Delegated Report

Householder Planning Application

Planning Application No: 20240824

Description: Installation of a dropped kerb to create hardstanding for parking with retaining wall.

Proposed Development

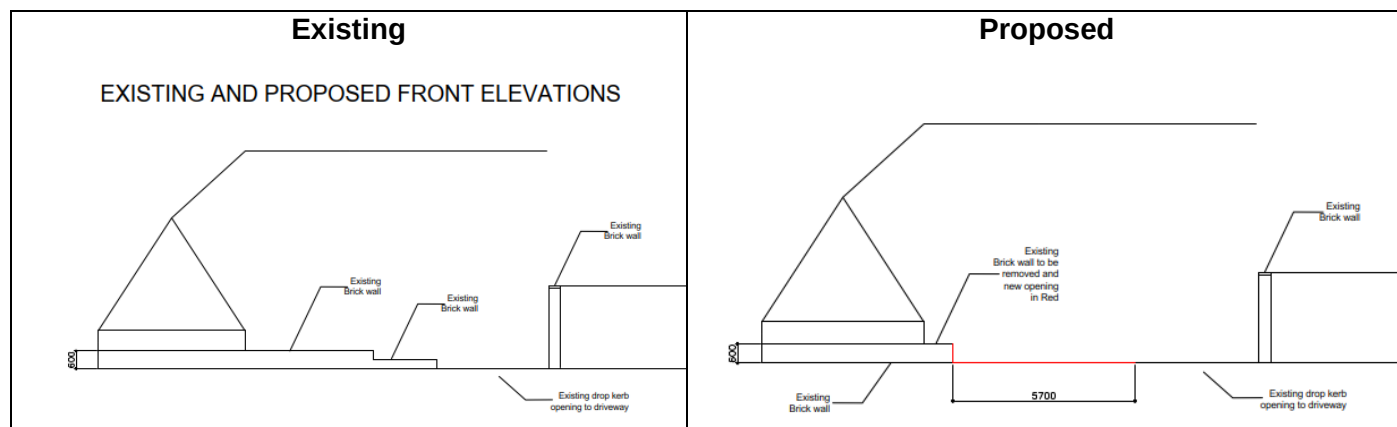
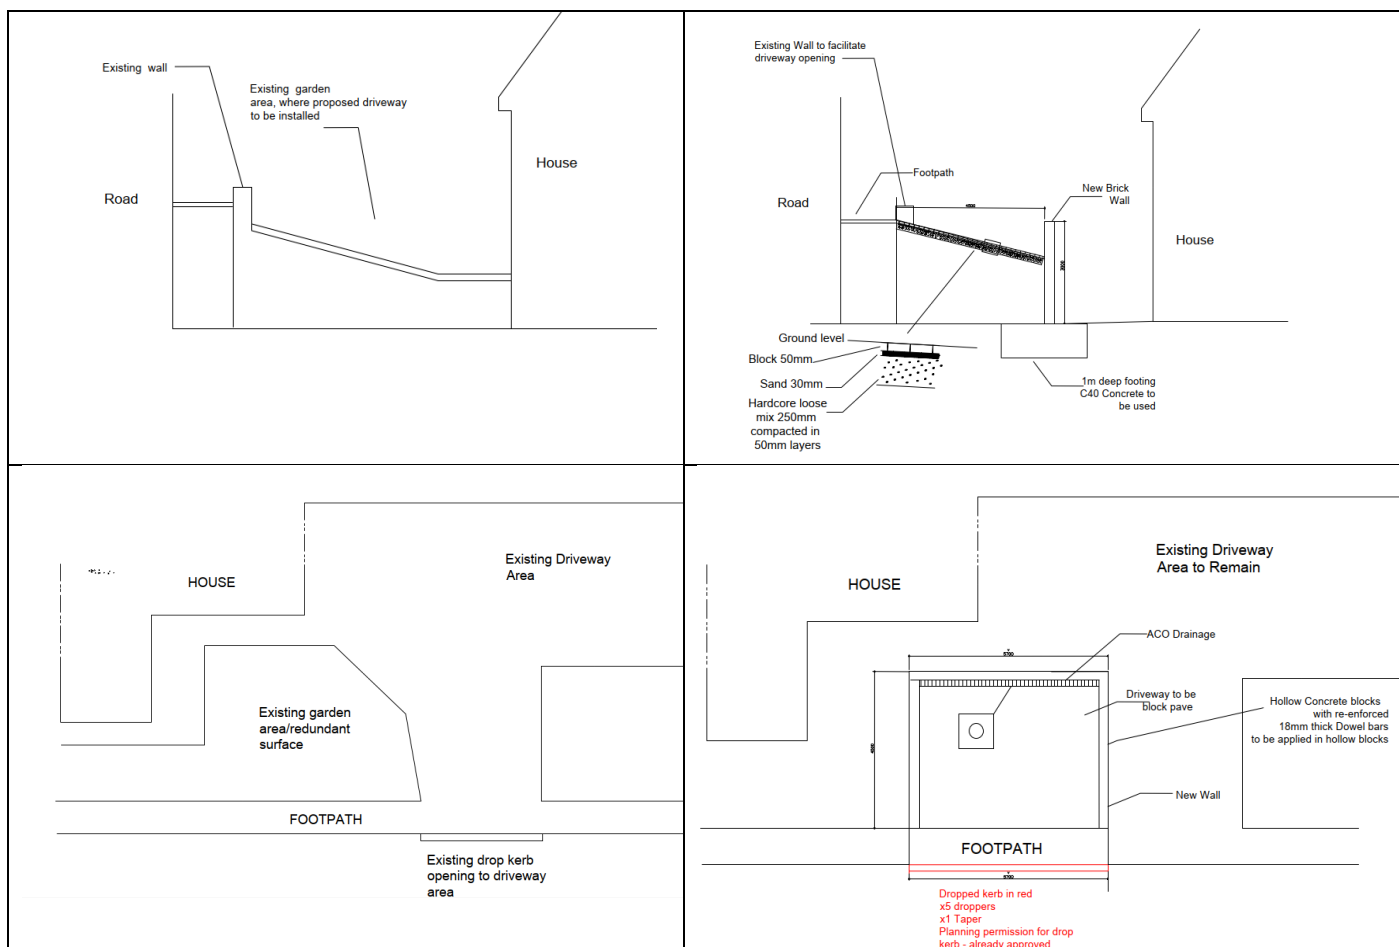
It is noted that crossovers and hardstanding areas are a common feature along this part of Leith Road and as such, having or extending a driveway is not considered to be out of character. However, the plans submitted for this proposal are not aesthetically pleasing and would represent a harsh form of development that would elevate and project the hardstanding area into the street scene environment. This is particularly apparent now that the front boundary wall has been reduced, exposing the existing hardstanding area. It is evident that a significant amount of the forecourt is already taken up as a parking area, no soft landscaping is proposed and therefore, the proposal for further hardstanding is considered to be harmful. This was found to be the case by the Planning Inspector for the recent dismissed appeal for 27 Hillingdon Road (ref:APP/K2230/D/24/3351826) (Appendix 1) whereby the Inspector stated, '*cumulatively such urbanisation detracts from the street scene.*' As the works require planning permission, designs should incorporate soft landscaping within the proposals. The new parking area itself is substandard in size, which shall be assessed further in the highways and parking section of this report. Therefore, there would be no space, or

opportunity for planting to soften the proposal. As such, a soft landscaping condition is not guaranteed to be sufficient to mitigate the harm to the visual amenity of the streetscene and the host dwelling itself.

Consequently, the proposed development would result in harm to the character and appearance of the host dwelling, streetscene and surrounding area, contrary to Policy CS19 of the Gravesham Local Plan Core Strategy (LPCS) (2014) and Section 12 of the National Planning Policy Framework (NPPF) (2023.)

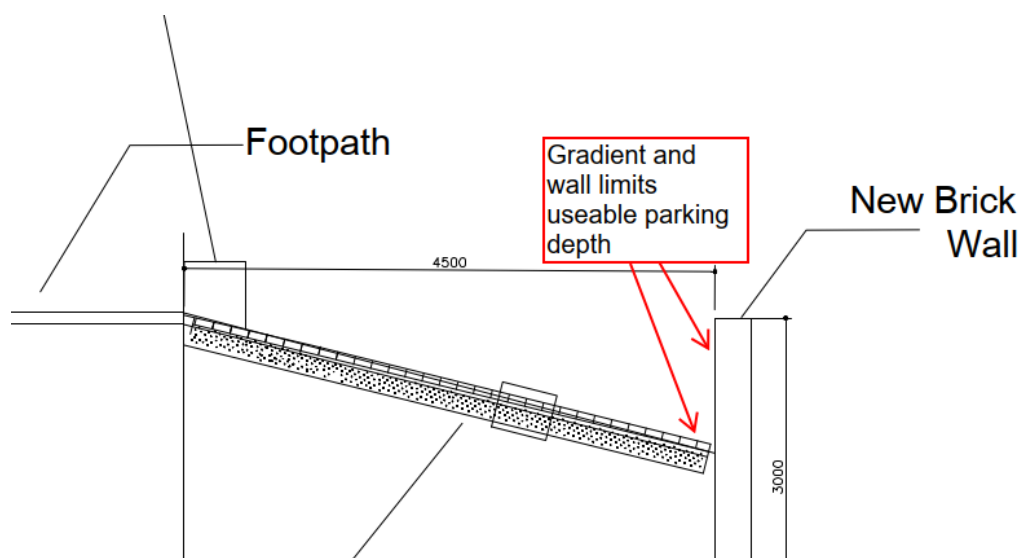
SPG4 KCC Parking Standards (2006) and Gravesham's Design SPD (2021) set out the minimum sizes for car parking bays. Car parking spaces should be a minimum of 2.50m wide (2.70m where spaces adjoin an enclosed boundary) and 5.00m deep. The plans submitted with this enquiry demonstrate that the proposed hardstanding area would be substandard and contrary to the requirements of the Design SPD (2021) and SPG 4 – KCC Parking Standards (2006):

Furthermore, the parking space would be on a slope, with a retaining wall, which further limits the size of the parking area:

As such the car would likely overhang the pavement, which would be unacceptable. The plans provided are lacking in sufficient detail. It is unclear how many bedrooms are in this property and whether the proposal would exceed the maximum vehicle standards
